SINGLE ENVIRONMENTAL IMPACT REPORT

**ALDEN FIRE STATION
140 LYNNWAY, REVERE MA**

Subject: **Alden Fire Station**
140 Lynnway
Revere, Massachusetts

ATTACHMENT 1
EXISTING CONDITIONS PLAN

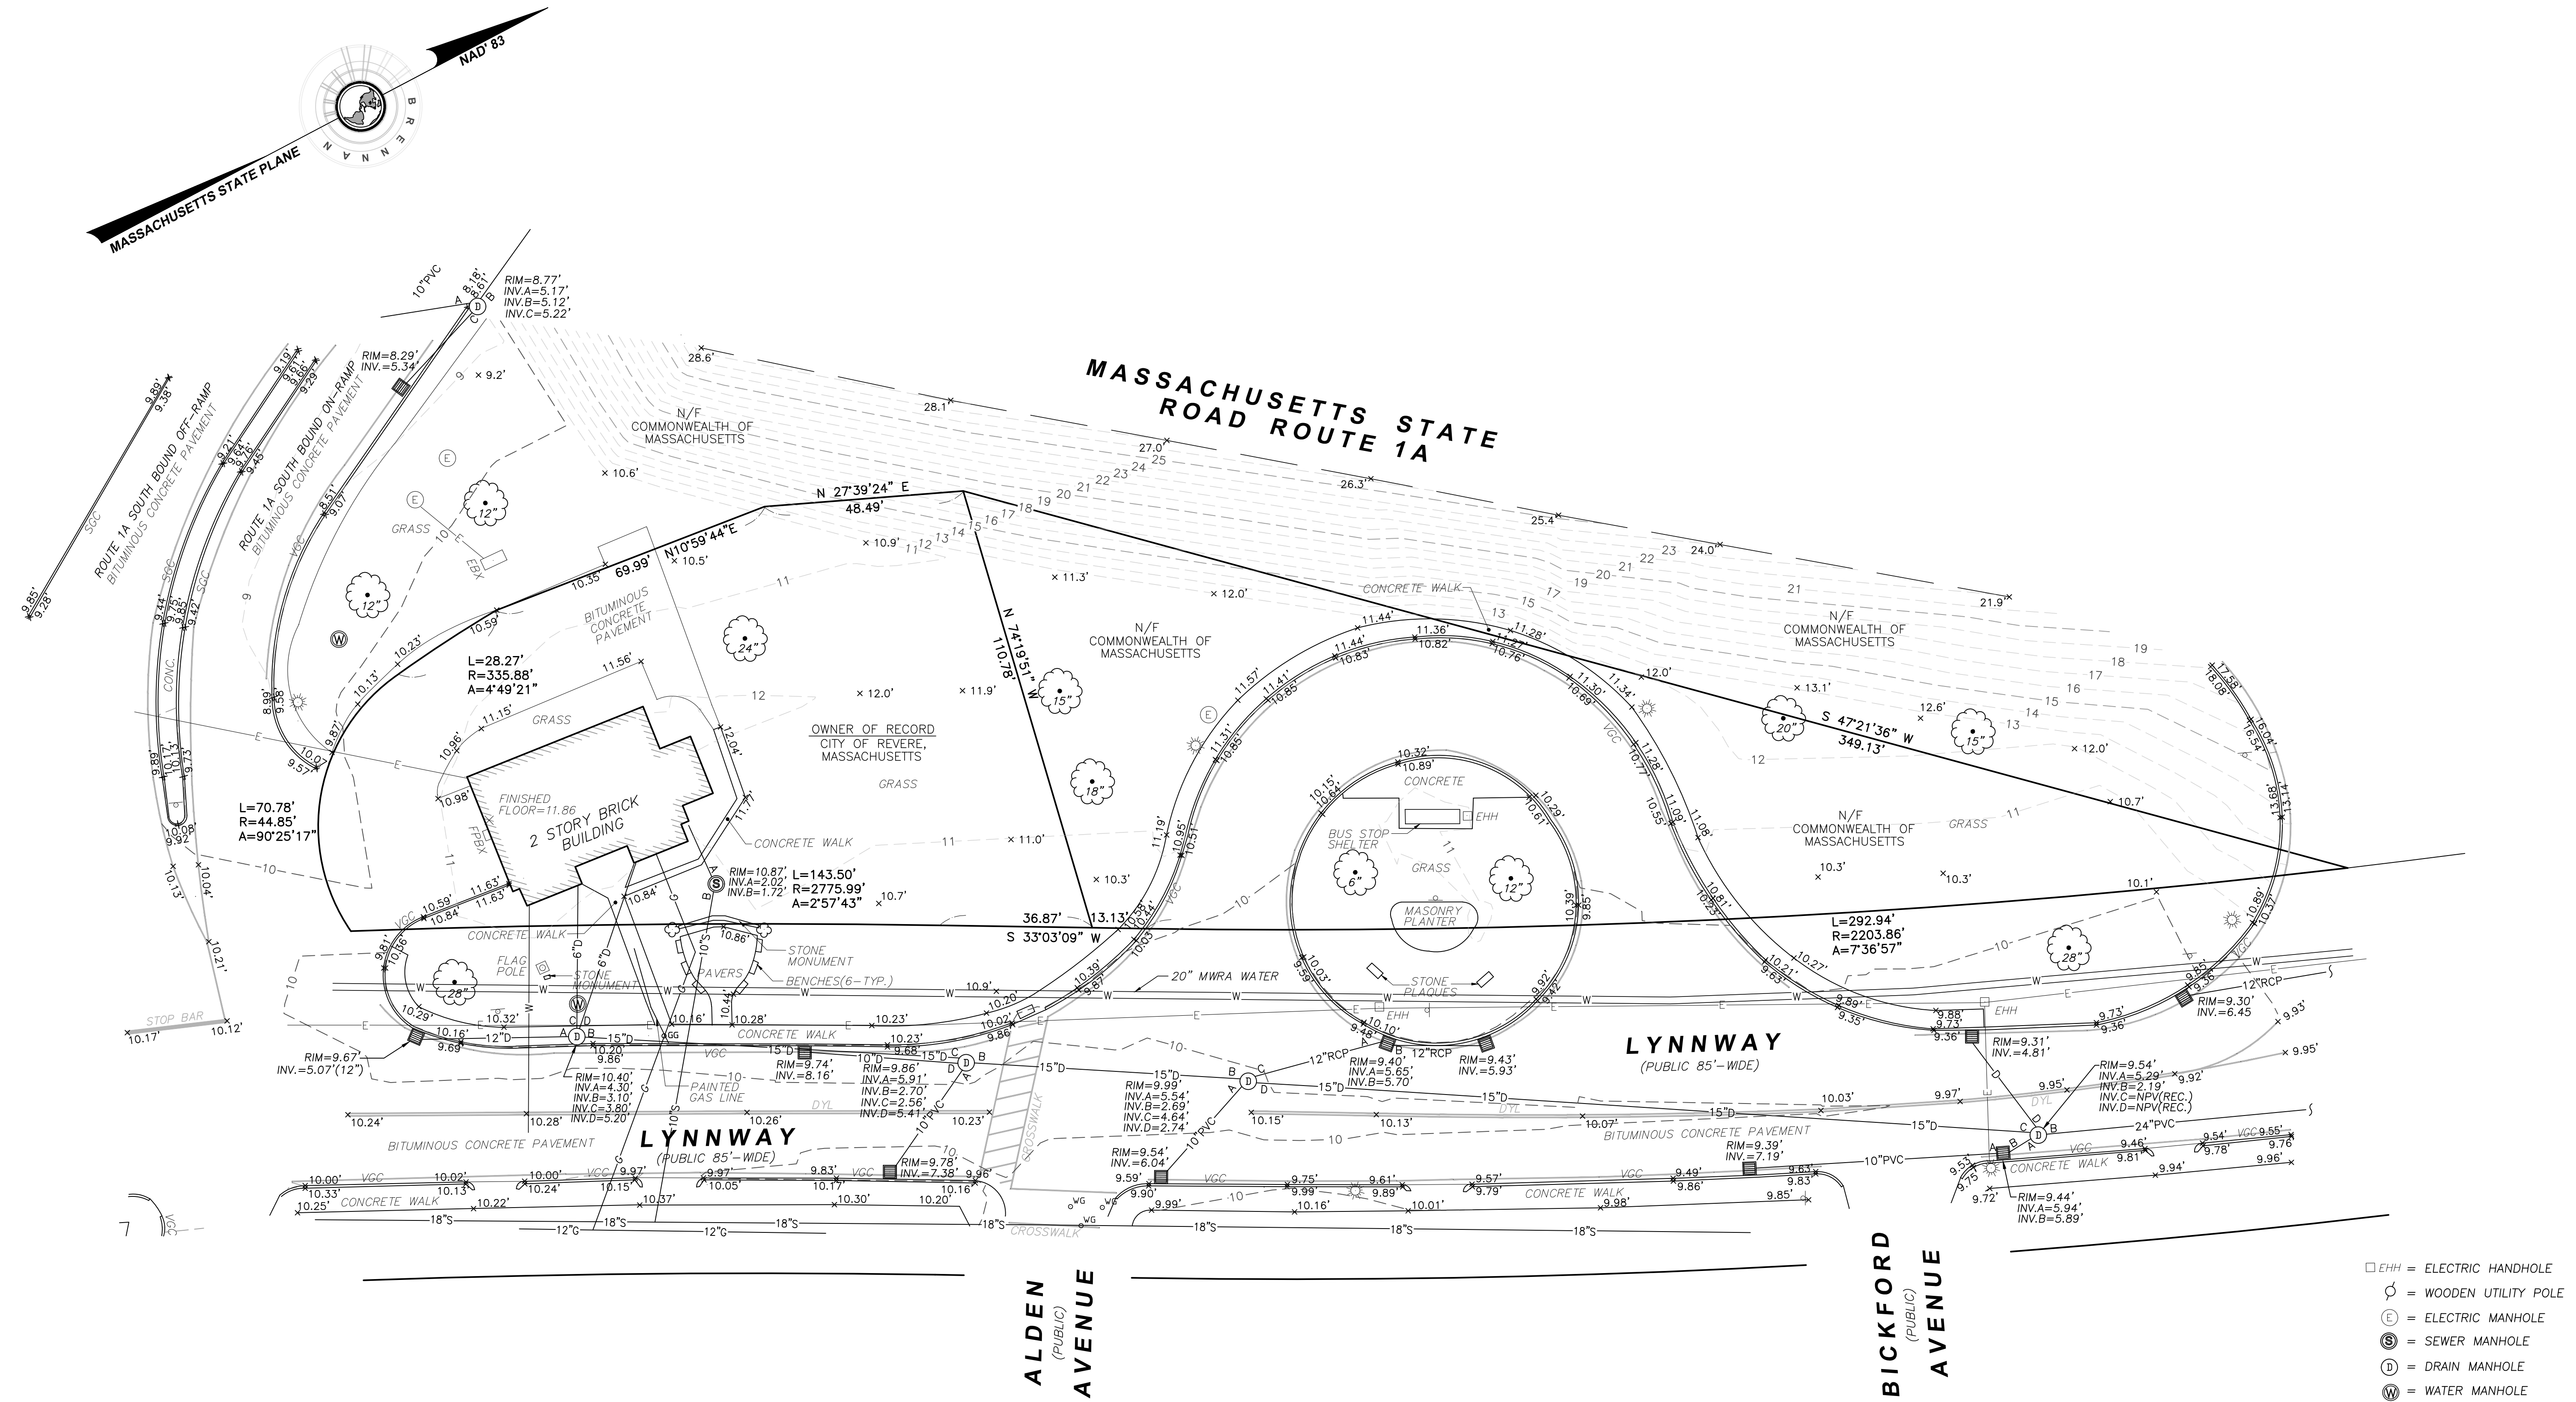
elevation, whichever is higher. A site plan in the EENF shows the building site to be above elevation 11 (no datum specified). According to the Proponent, the datum used is NAVD 1988, which would render the building site above the base flood elevation for that location. Elevation of the building site, with datum source specified, will need to be verified as it appears to be inconsistent with what is depicted on the FIRM.

Elevations depicted on the site plans are based on NAVD88 and were field verified. Horizontal datum is NAD 83. See Attachment 1.

SITE CROSS SECTIONS

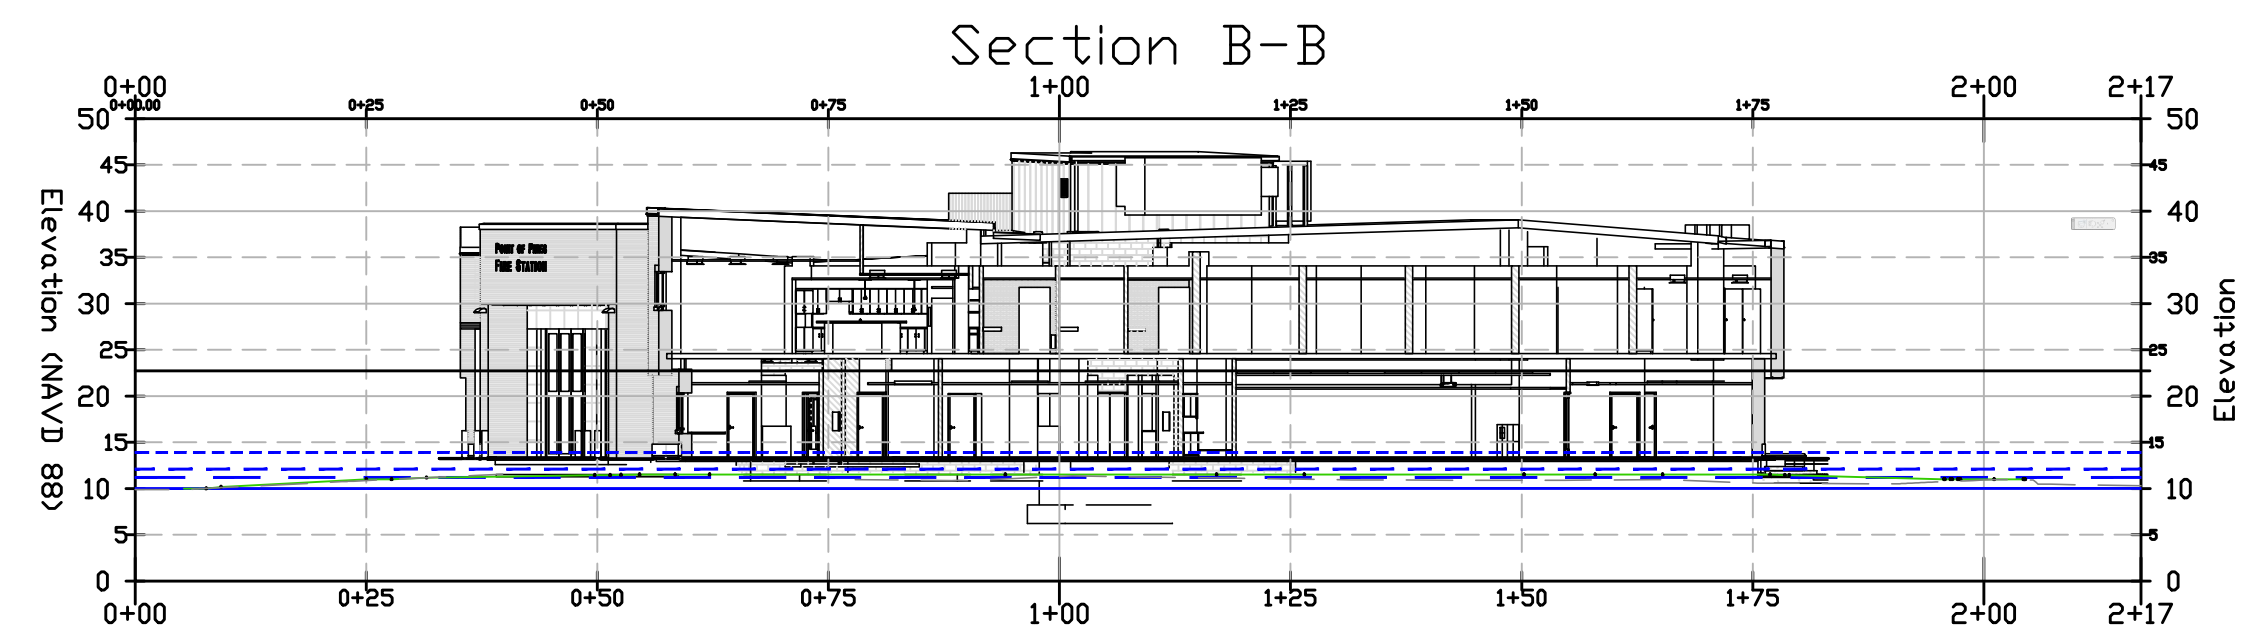
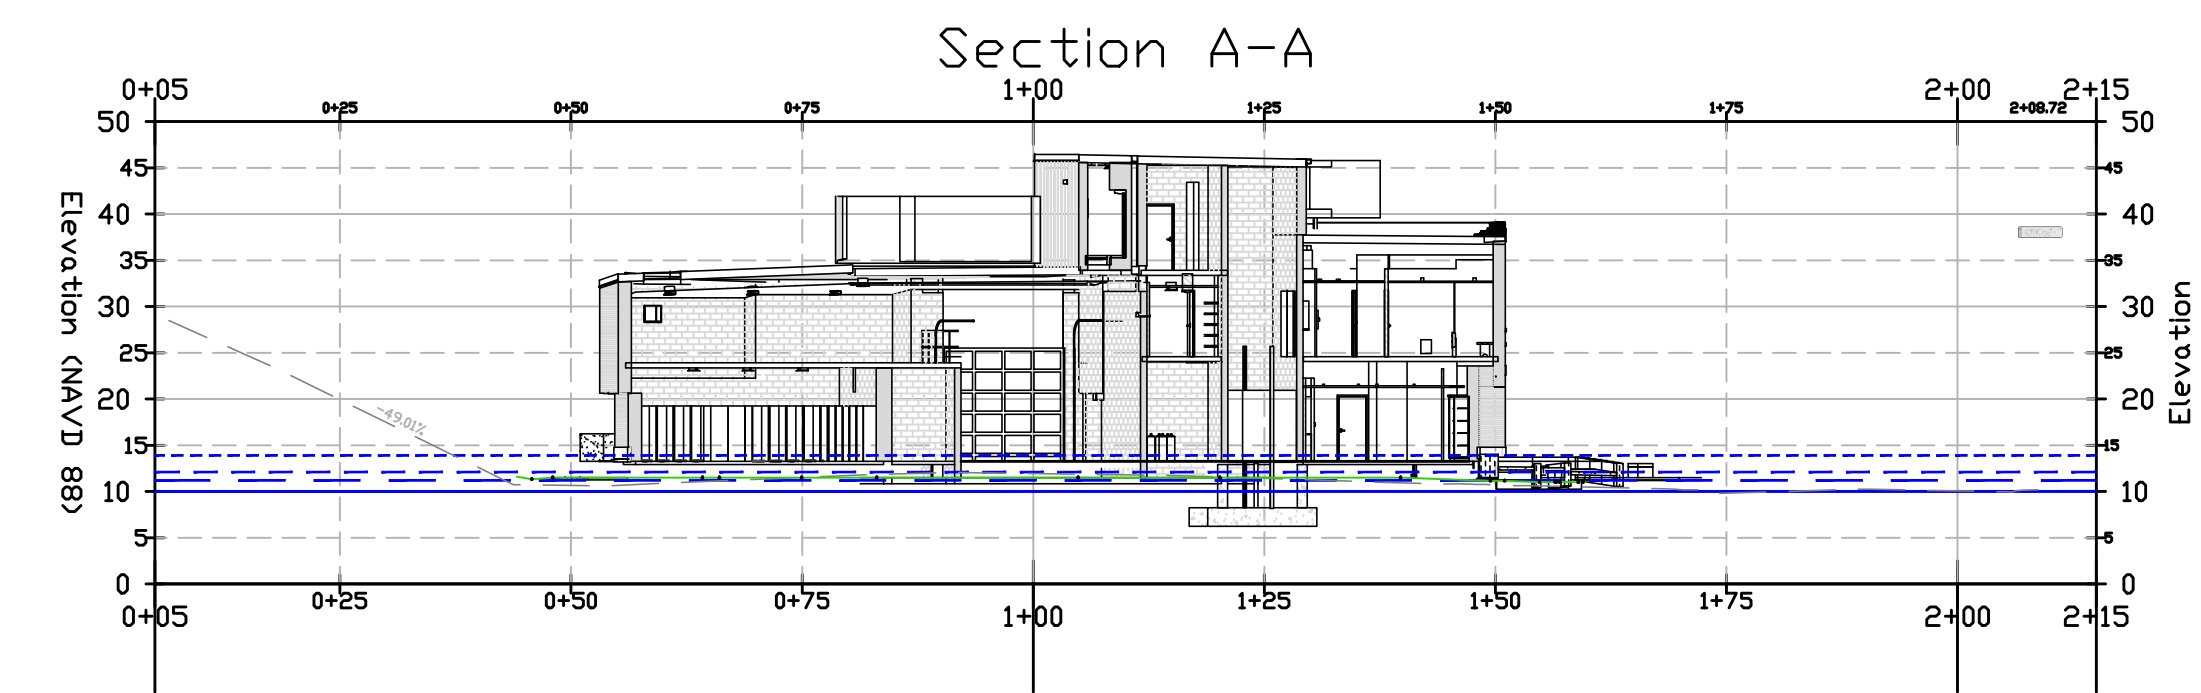
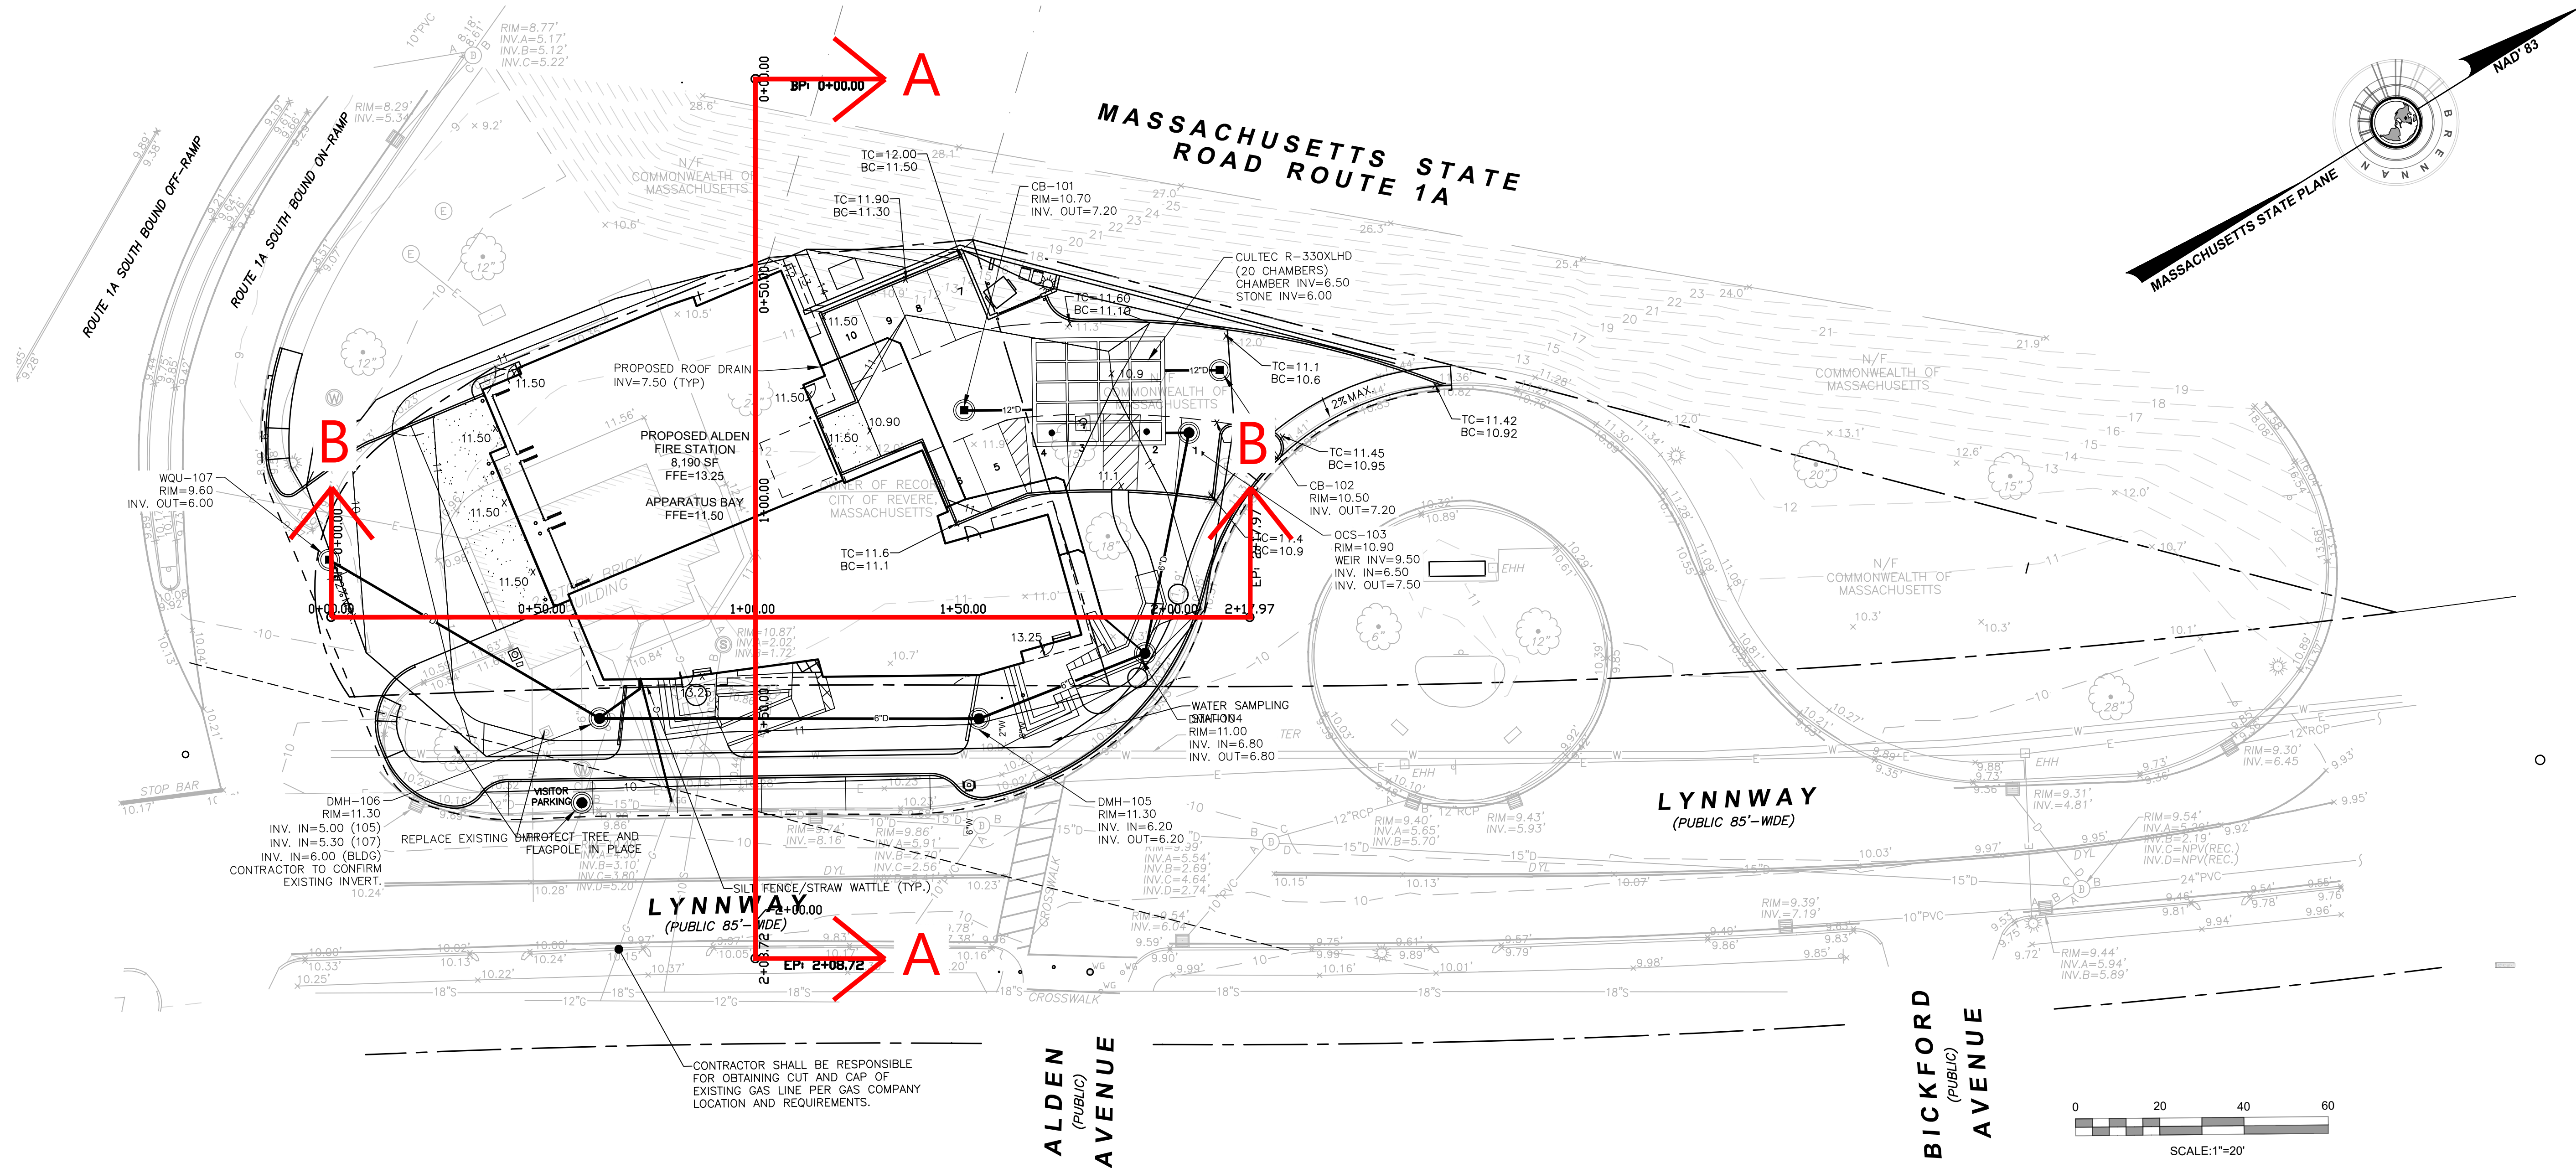
The Single EIR should provide cross-sections through the site and proposed buildings with existing and proposed grades, exterior structures such as utilities and site access facilities, the FEMA 100-year flood elevation, and future projected flood elevations, and should explain in detail how the building has been designed to be resilient to climate conditions over a 30 to 50 year design life. The Single EIR should discuss whether it would be feasible to elevate the building to be resilient to 100-year and 200-year storm flood conditions as of 2050 and 2070. If not feasible, the Single EIR should discuss whether the City plans to follow an adaptive management strategy and whether future retrofits may be possible to improve resiliency. The Single EIR should discuss what contingency plans exist for surrounding communities, should future storm conditions make the fire station inoperable.

The ENF states that the building finish floor will be 1.5 feet above the 100-year flood elevation, at elevation 11.5 NAVD88. Plans showing cross-sections through the site with the existing grades, proposed grades, proposed buildings and structures, FEMA base flood elevations, and future projected flood zone elevations, as well as grading plans to show how the site will be elevated should be provided in the EIR to demonstrate that the site is designed appropriately for the existing and expected conditions for the site during the design life of the project. The EENF indicates a project design life of 30 years. The Massachusetts Coastal Flood Risk Model (MC-FRM) data indicates there will be 2-3 feet of flooding in a 1% storm on this site location by 2050. Because the fire station is a critical facility, it should be designed for protection from a 500-year event for the life of the building. The EIR should demonstrate that these considerations have been applied in the design of the building elevations and site approaches. For example, a transformer on the site plans appears to be at grade; all utilities should be elevated to provide the maximum protection from flooding for the design life of the building. Addressing these issues in the design of this critical facility will improve the function of the facility to provide emergency assistance over time in this vulnerable location.

- 13.25 = BUILDING FFE
11.5 = APPARATUS BAY FFE
16.5 = FLOOD PROOFING EL
- FEMA 100-YEAR FLOODPLAIN ELEVATION (10.0)
 - FEMA 500-YEAR FLOODPLAIN ELEVATION (11.2)
 - PROJECTED 2050 200-YEAR FLOODPLAIN ELEVATION (12.1)
 - PROJECTED 2070 200-YEAR FLOODPLAIN ELEVATION (13.9)
